BURLINGTON DEVELOPMENT REVIEW BOARD

Tuesday, October 6, 2015

MEMORANDUM

To: Development Review Board
From: Mary O'Neil, AICP, Senior Planner
Date: October 6, 2015
RE: ZP16-0263CA 584 South Prospect Street

# EXISTING CONDITIONS SITE PLAN

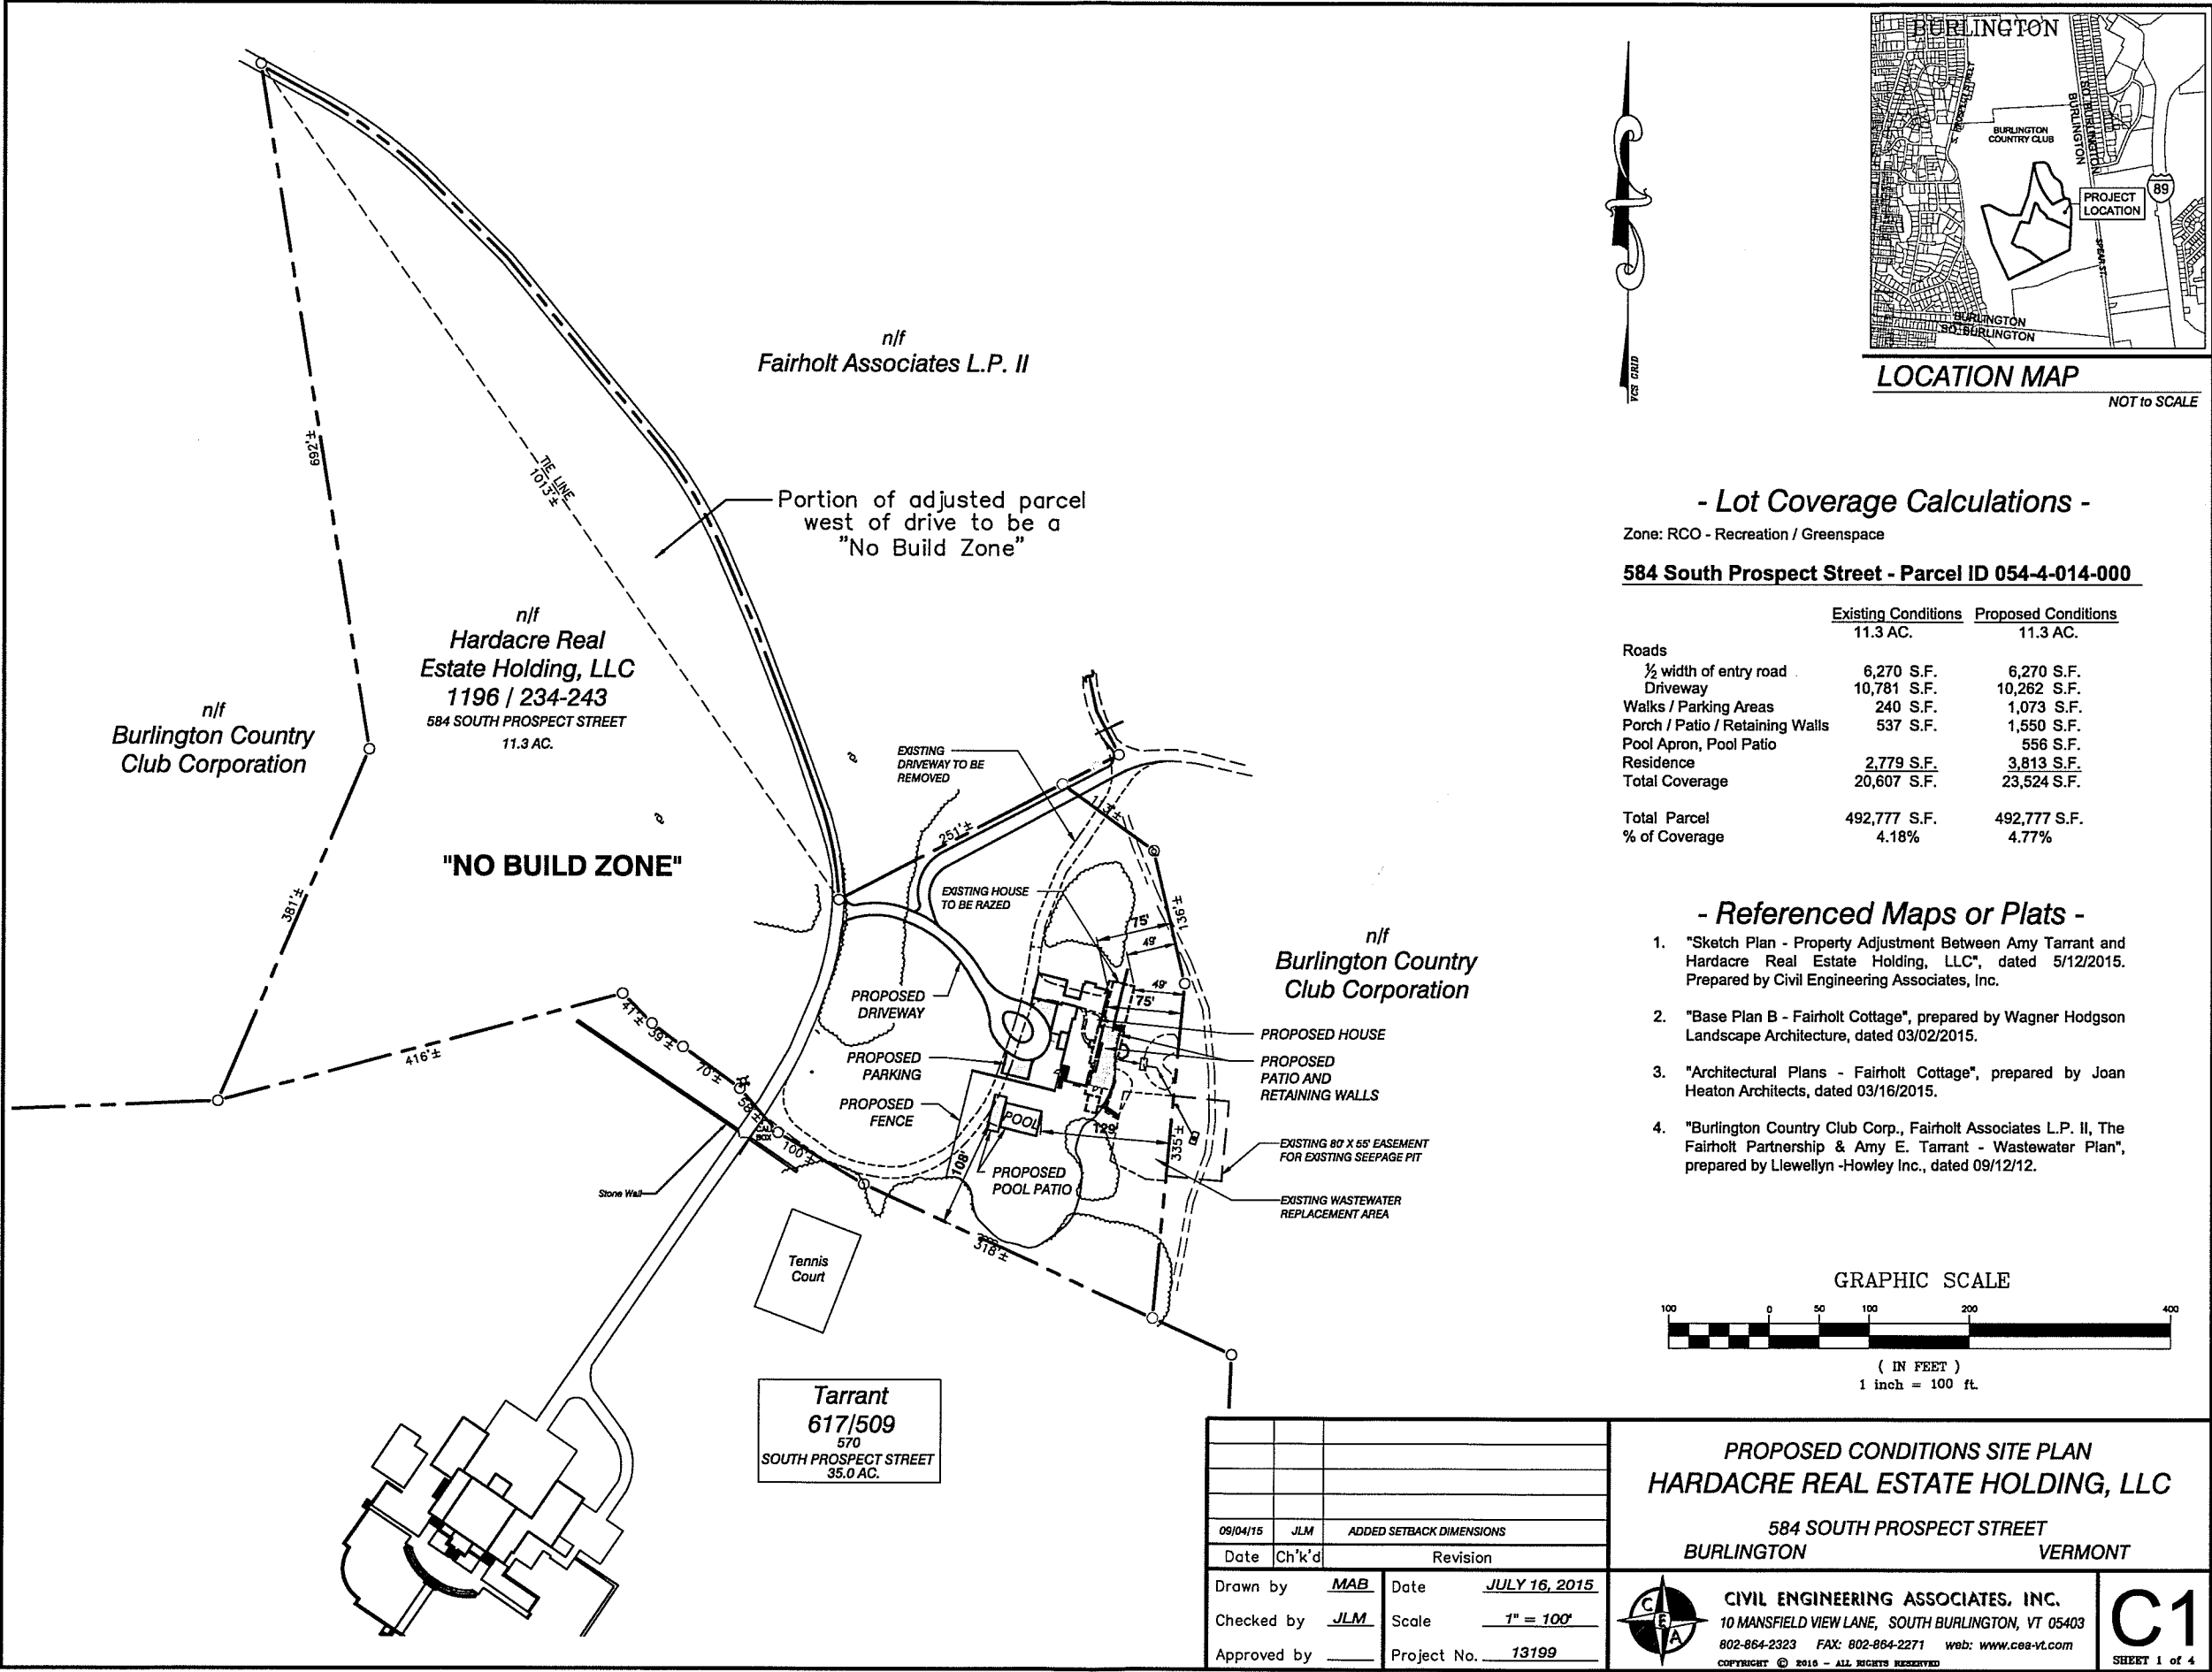
The applicant has provided a breakdown of topography and slope. There are no slopes over 30%. Slopes between 15 and 30% are identified to the east of the development area. (See *Plan C1.0, Existing Conditions Site Plan, Slope Analysis*.) In an email dated September 18, 2015 the engineering consultant provides:

EXTERIOR  
ELEVATIONS

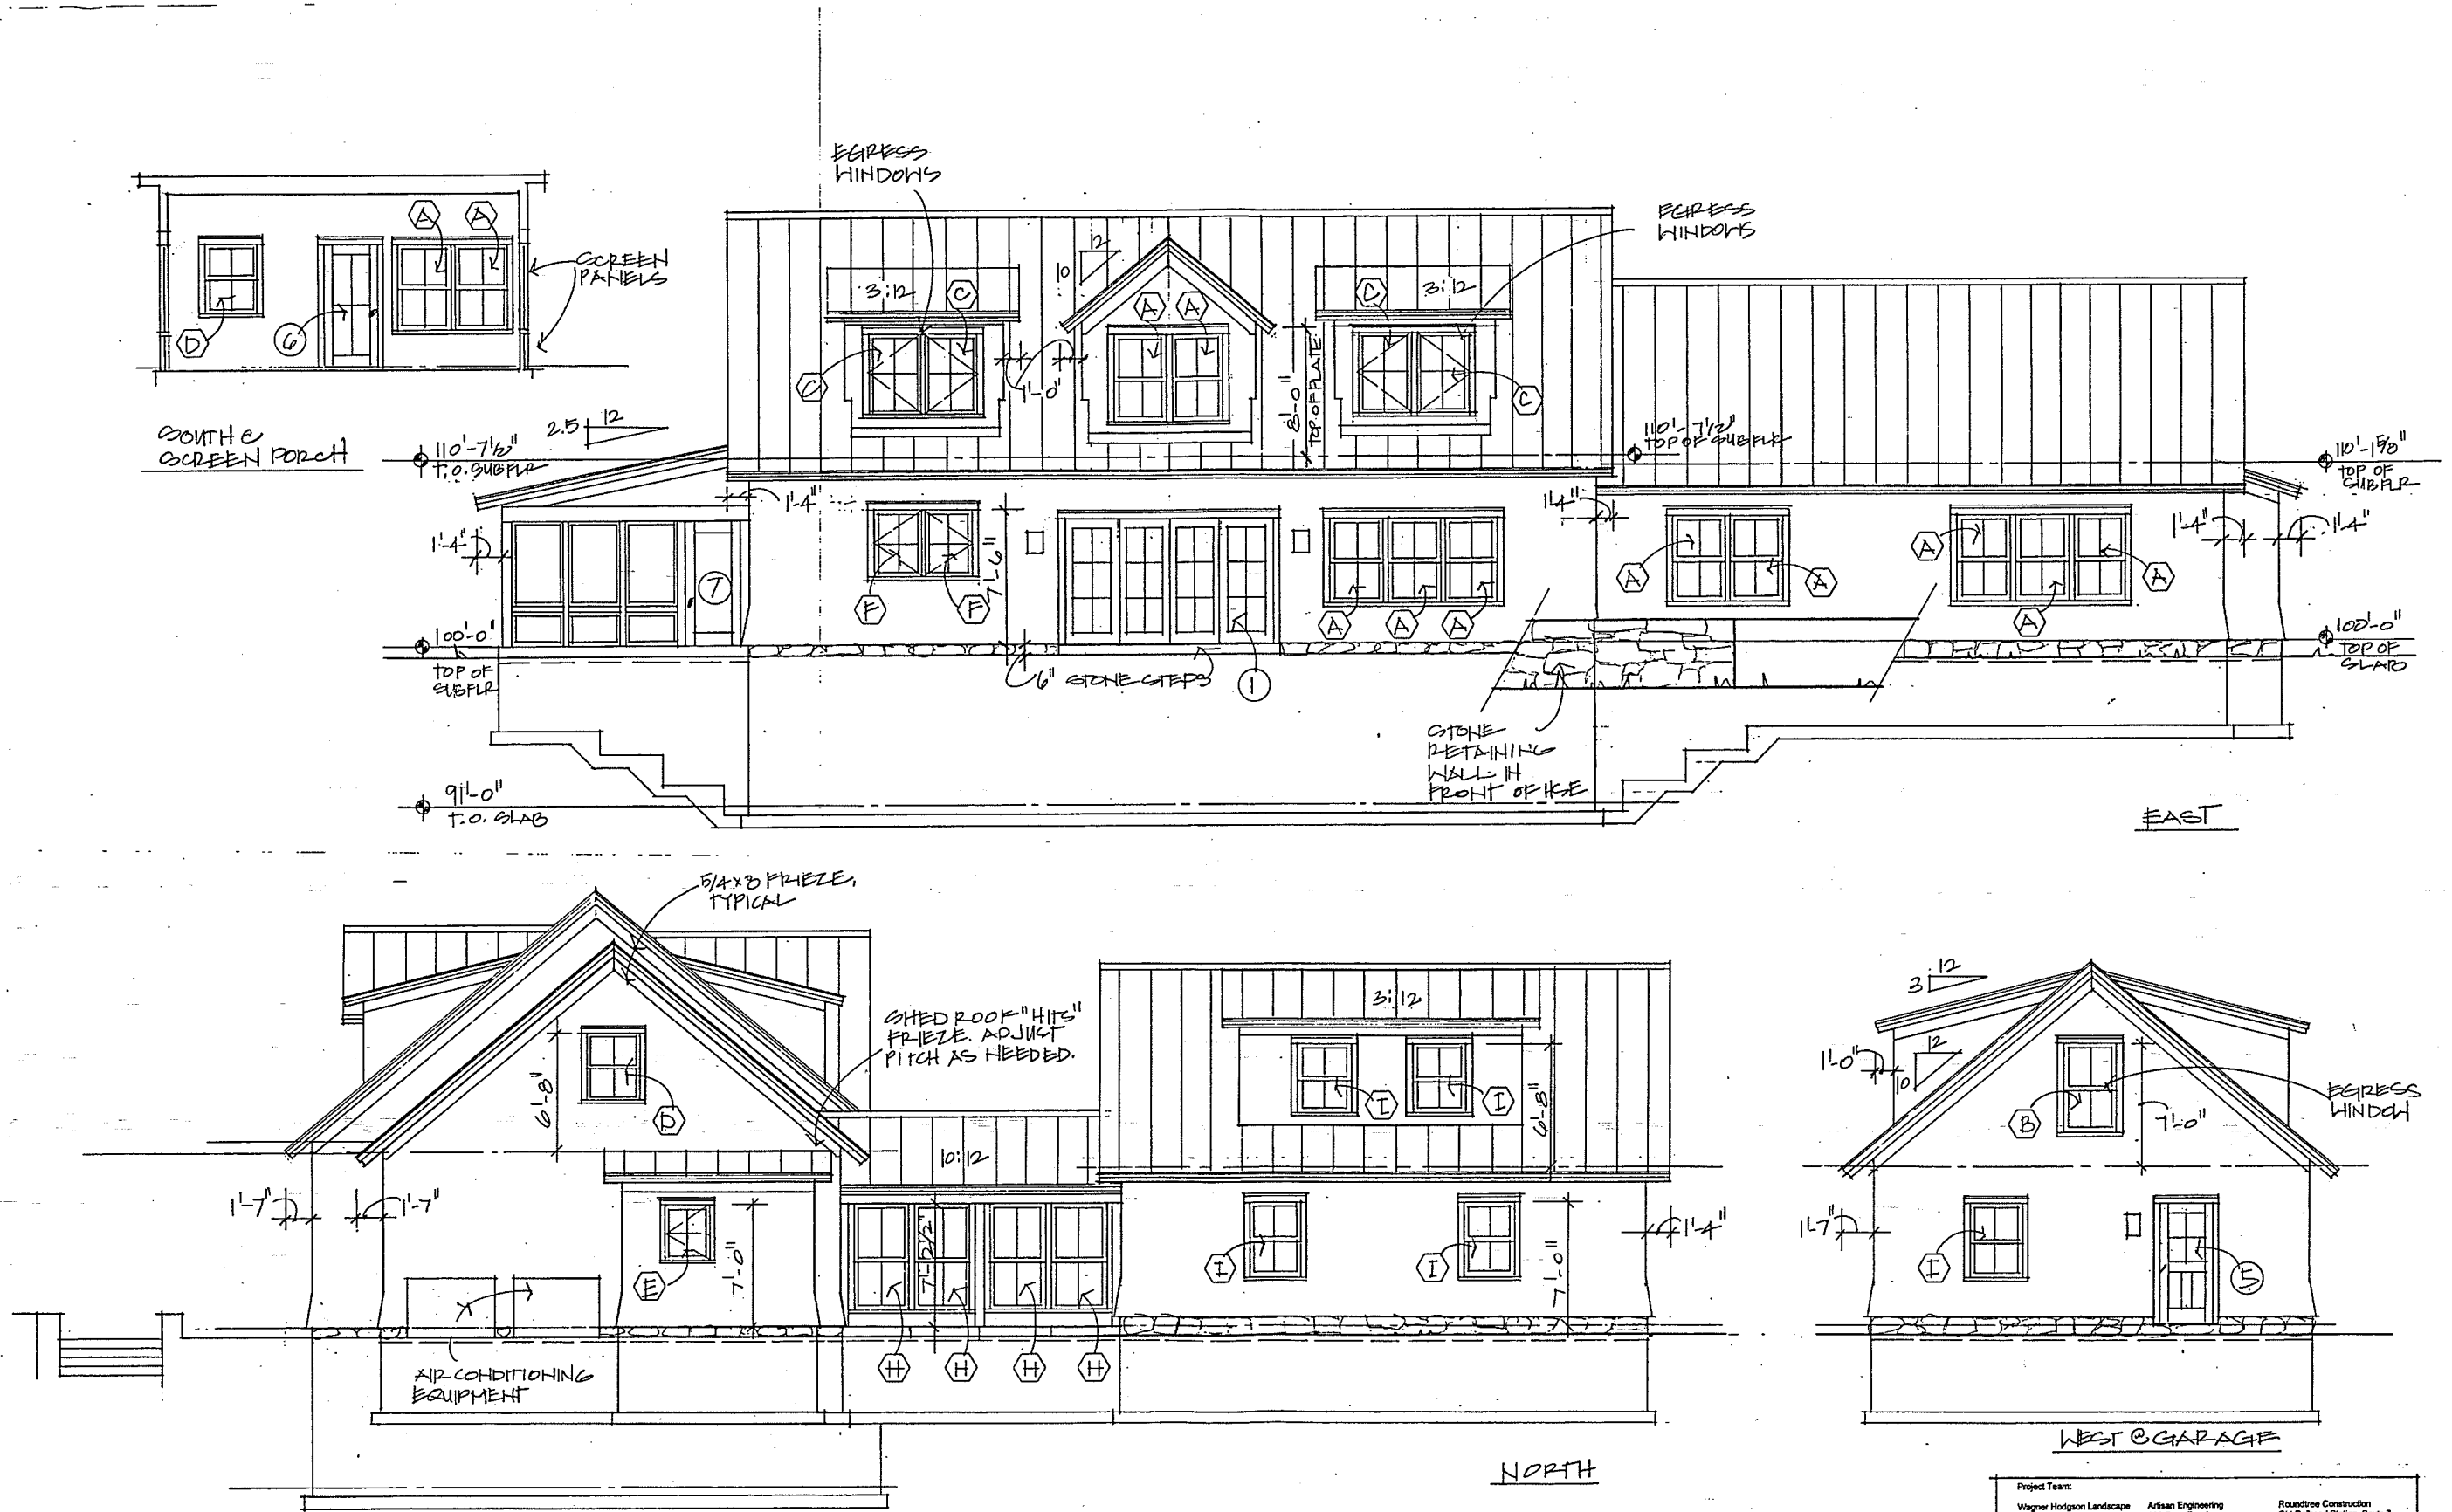
A site lighting plan prepared by Wagner Hodgson has been submitted, and reflects low level LED lighting. Sconce type fixtures are abbreviated in building elevations; any exterior building mounted lighting will need to be submitted for review and approval by staff.

Ground mounted a/c mechanicals are proposed for the north elevation. As located on the north elevation and behind a small structural projection, additional screening does not appear to be necessary. Other utility connections are not evident on the plans, and need to be annotated on site and/or building elevations as appropriate.

3. Sconce-type illumination is identified on elevation plans. Fixture cut sheets for any exterior lighting shall be provided to staff for review and approval **prior to release of the zoning permit.**
